Adopted proposal for amendments to Regulation No 46

Insert new paragraphs 15.2.4.5.6. to 15.2.4.5.13. (including new Figures 8c and 8d), to read:

Figures 8c and 8d:
Larger field of vision on the passenger side

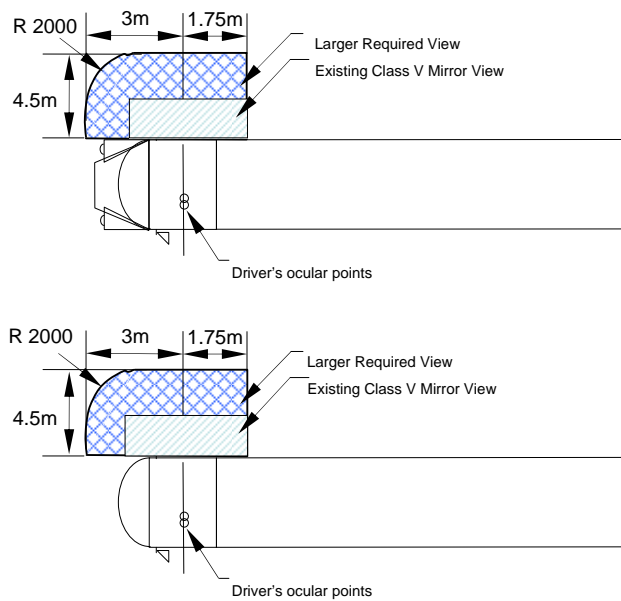
- "15.2.4.5.6. on the passenger side only, the field of vision shall also be such that the driver can see a flat horizontal portion of the road along the side of the vehicle which is outside the field defined in paragraphs 15.2.4.5.1. to 15.2.4.5.4. but within the field bounded by the following vertical planes; the front of this field of vision may be rounded off with a radius of 2000 mm (see Figures 8c and 8d):**

- 15.2.4.5.7. in the transverse direction, the parallel plane passing at a distance of 4.5 m in front of the plane mentioned in paragraph 15.2.4.5.1.**

- 15.2.4.5.8. to the rear, the plane parallel to the vertical plane passing through the driver's ocular points and situated at a distance of 1.75 m behind that plane.**

- 15.2.4.5.9. to the front, the plane parallel to the vertical plane passing through the driver's ocular points and situated at a distance of 3 m in front of that plane. This field of vision may be partially provided by a front mirror (Class VI).**

- 15.2.4.5.10. The field of vision prescribed in paragraphs 15.2.4.5.6. to 15.2.4.5.9. may be partially provided by a 'wide-angle' exterior mirror (Class IV) or a combination of a close-proximity exterior mirror (Class V) and a front mirror (Class VI).**

- 15.2.4.5.11. The area prescribed in paragraphs 15.2.4.5.6. to 15.2.4.5.9. may be viewed using a combination of direct view and indirect vision devices.**

- 15.2.4.5.12. Paragraphs 15.2.4.5.6. to 15.2.4.5.9 shall not apply to a vehicle where no part of the mirror, or its holder, is less than 2.4 m above the ground, regardless of its position after adjustment.**

- 15.2.4.5.13. Paragraphs 15.2.4.5.6. to 15.2.4.5.9 shall not apply to a vehicle of category M₂ or M₃.**
